REPORT TO CITY OF VISALIA PLANNING COMMISSION

HEARING DATE: May 26, 2015

SUBJECT: Conditional Use Permit No. 2015-03: A request by Raj Verma, Ayan Hospitality,

LLC, to allow an amendment to Conditional Use Permit No. 2007-39 which adopted a master-planned development on 29 acres in the Business Research Park (BRP) zone, and to allow the development of a 95-room, 68,455 sq. ft. hotel on 2.66 acres in the BRP zone. The project site is located at the northwest corner of Plaza Drive

SITE PLAN FEB. 25 2015

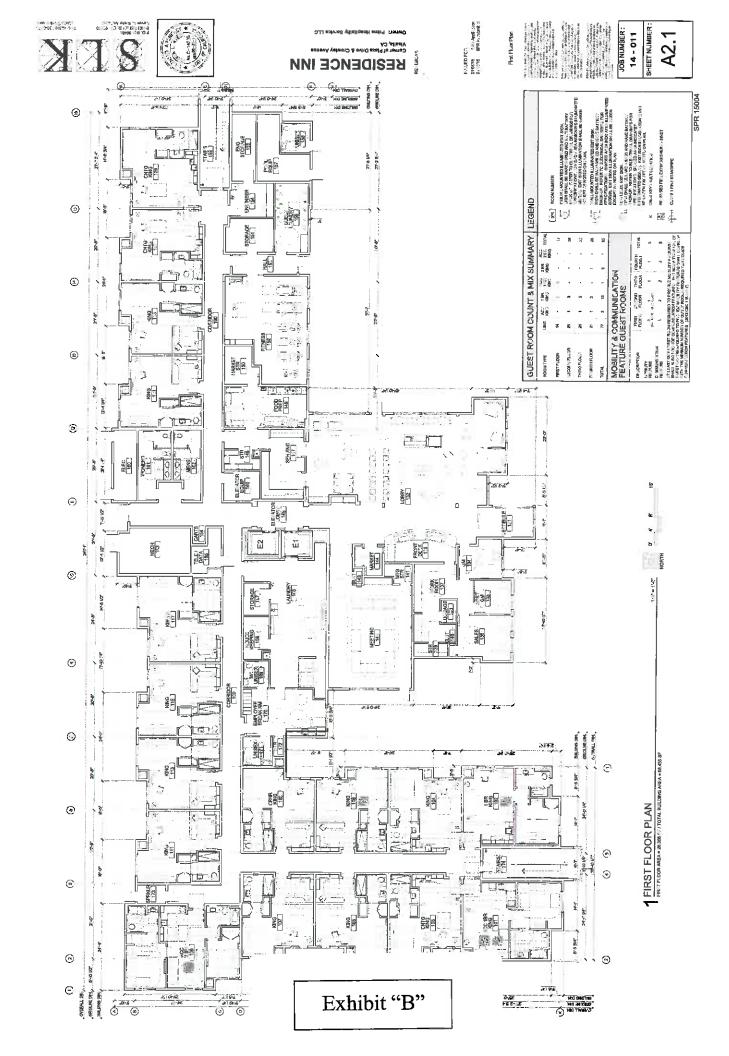
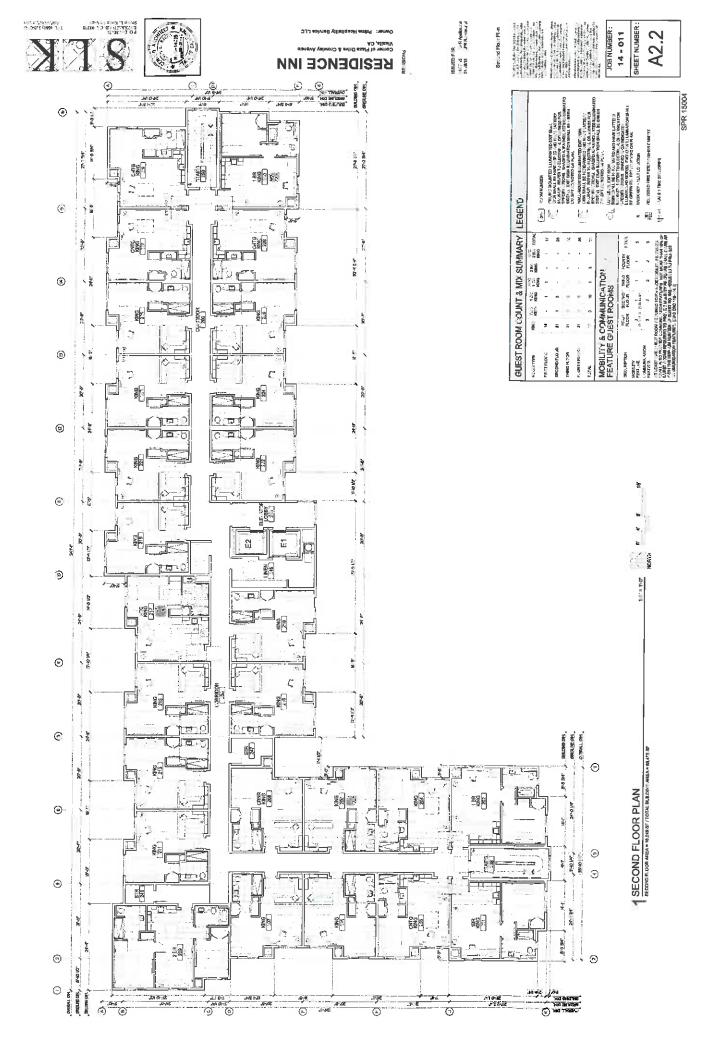
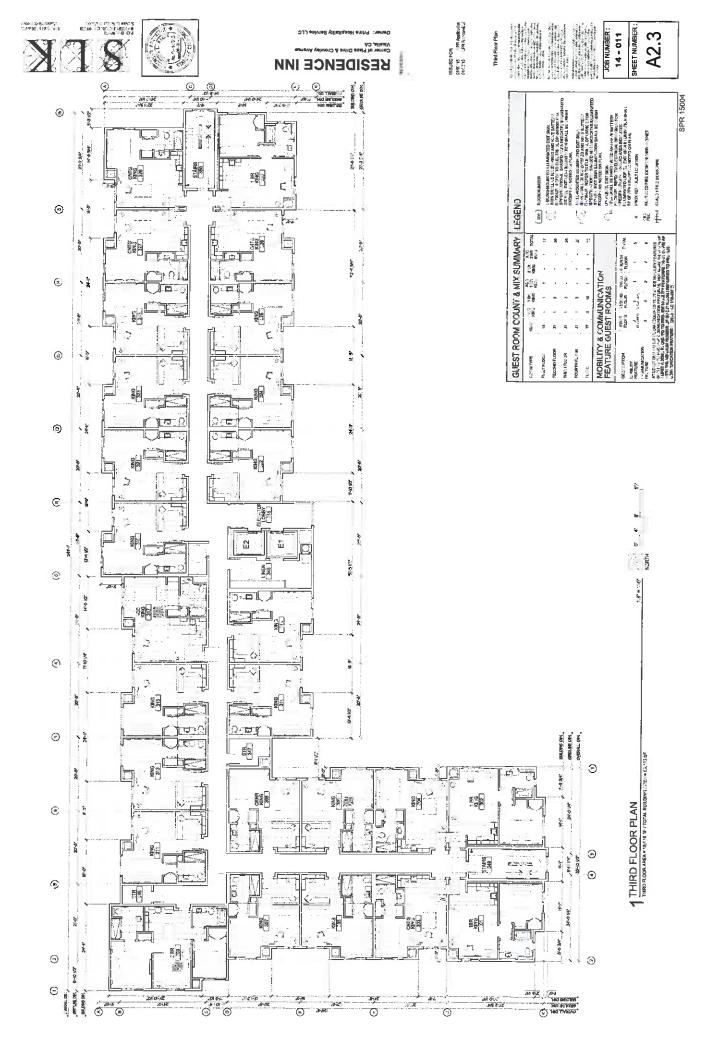
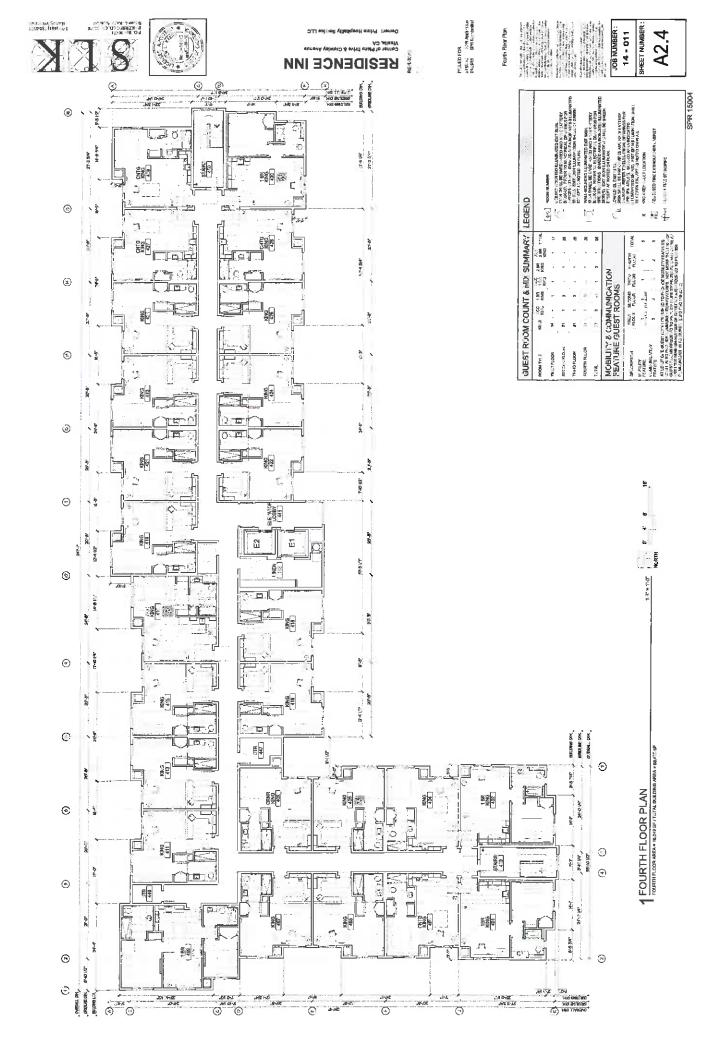
Hotels are required to provide one parking space for each guest room and one parking space for each two employees per shift regularly employed by the hotel. Based on the number of rooms, number of employees as stated in the site plan (see Exhibit "A"), and the meeting room, a total of 99 parking spaces are required. The hotel is providing 102 parking spaces on-site.

2 LEFT SIDE ELEVATION

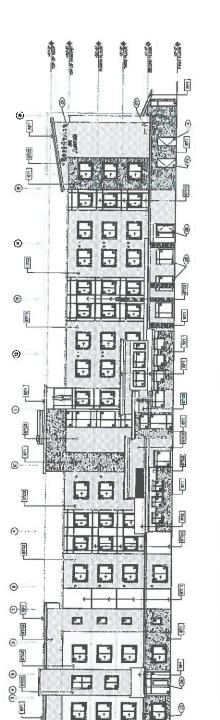
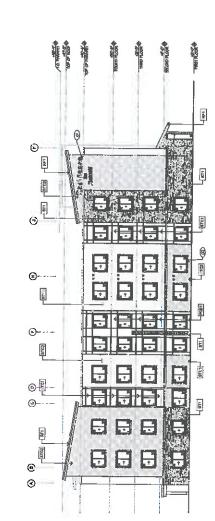
Exhibits "C" and "D" provide building elevations proposed for the Marriott Residence Inn hotel. The elevations depict pitched roofs, stacked ledger stone, plastered walls and stone buttresses.

As described in the analysis above, the elevations do not conform to all of the building design criteria of the Plaza Business Park Master Plan. Following is a list of the design criteria required by the Appendix G of the master plan and staff's evaluation of the proposed hotel elevations:

continuous glazing. The elevations show individual windows without

parapeted elements that are taller than the sloping roof. The elevations show a flat roof with main and corner entries utilizing sloping roofs, with no mansard hipped sections shown anywhere.

with curved steel framing on multi-story buildings. The elevations show flat canopies over the main entry and sloping roofs over the side

Based on the amendment to the design guidelines to accommodate corporate tenants, the elevations are consistent with the guidelines based on its incorporation of some of the required architectural elements and its attempt to adapt to the master plan's architectural theme. A representative from the Plaza Business Park Design Review Committee has also submitted correspondence in support of the CUP amendment (see Exhibit "K").
